**REPORT FOR
WESTBROOK CONDOMINIUMS
ANSONIA, CONNECTICUT**

Environmental Review Team Report

Prepared by the King's Mark Environmental Review Team
of the King's Mark Resource Conservation
and Development Area, Inc.

Ansonia Inland Wetlands Commission

ORIGINAL SITE PLAN

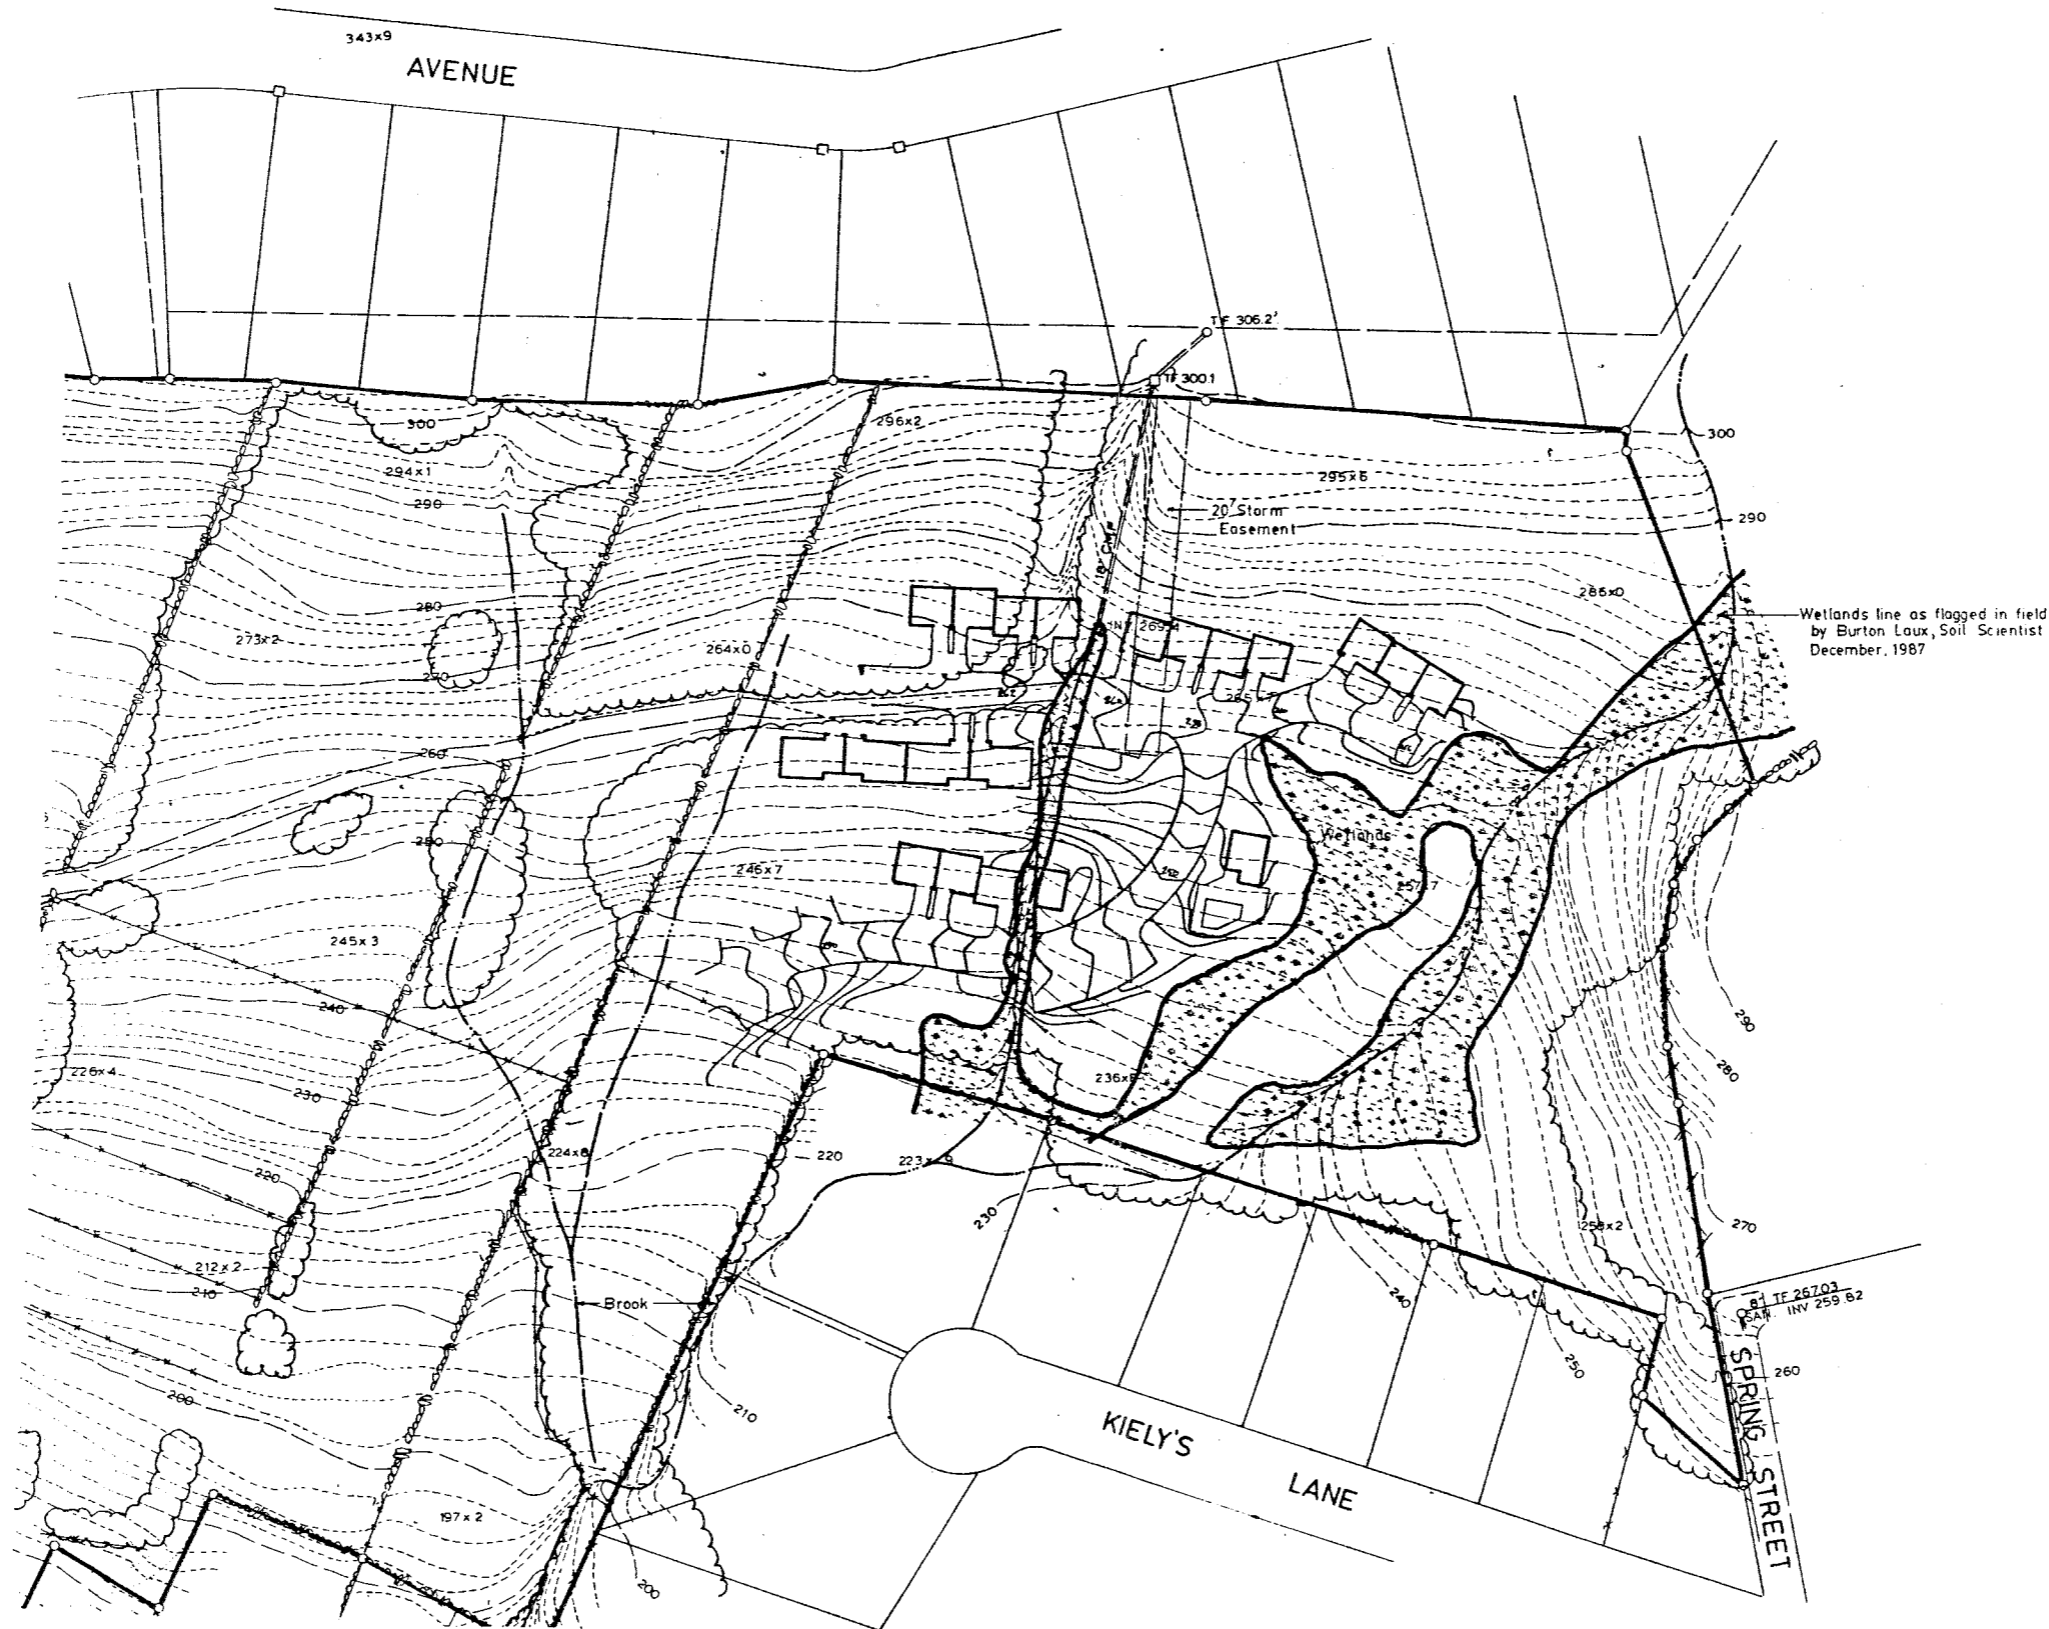
The presence of wetland soils and seasonal watercourses will limit the usefulness of the site's southern limits for development purposes. Present plans indicate that the road network will need to traverse or encroach wetlands/seasonal watercourses in several areas. Also, residential units are proposed over seasonal watercourses in several areas.

Although undesirable, wetland road crossings are feasible provided they are properly engineered. These roads need to be constructed adequately above the surface elevation of the wetland. This will permit better drainage of the road and also decrease the frost heaving potential. Road bed preparation needs to include removal of all organic material before the fill material is placed. In cut areas, underdrains should be installed on either side of the road. Road construction through wetlands should be done during the dry time of the year and should include provisions for effective erosion and sediment control. Culverts should be properly sized and located to prevent altering the water levels in the wetland and flooding.

In the original plans, the developer proposes a private street system to serve the proposed 97 multi-family housing units. The primary access would be off Jewett Street via a 760-foot entrance drive. Six housing units are proposed to be situated off the entrance drive.

The bulk of the housing units (68) are indicated to be double-loaded off a proposed loop road. The loop road is over 2,000 feet in length, looping around a "squashed oval" piece of land about 860 feet long by 160 feet wide.

Each of the above private roads is proposed to be 24 feet wide, approximately eight feet narrower than the City standard.

The developer is proposing to construct over a half mile of roadway, only 24 feet wide, to serve 97 multi-family housing units. Most of the housing units are double-loaded in pairs off the road system. For each housing unit, there is a private driveway to accommodate access to a parking space in a private garage. The private driveway serves as a potential second parking space for the housing unit. The private garage is a definite selling point for the project. The garage not only shelters the auto, but also reduces its visibility.

out so vehicles in the garages can become accessible, many of the visiting or resident vehicles are going to end up on the main drives, effectively reducing road width to about 16 feet. If vehicles are parked on opposite sides, only 8 feet would remain for a travel lane.

Due to the lack of separation from individual drives and parking areas, the developer does not appear to have warranted lessening of City standards in the width of the roadway serving the units. It is recommended that the the full width of City street specifications be required in order to provide for public health and safety.

In multi-family developments of 20 families or more, the recommended width of the drives is at least 32 feet and should be constructed to City standards for grade and alignment and to City specifications. However, when circulation driveways contain no parking spaces and are separated from parking areas and access aisles by means of curbs and/or islands, the driveway width may be reduced to 24 feet.
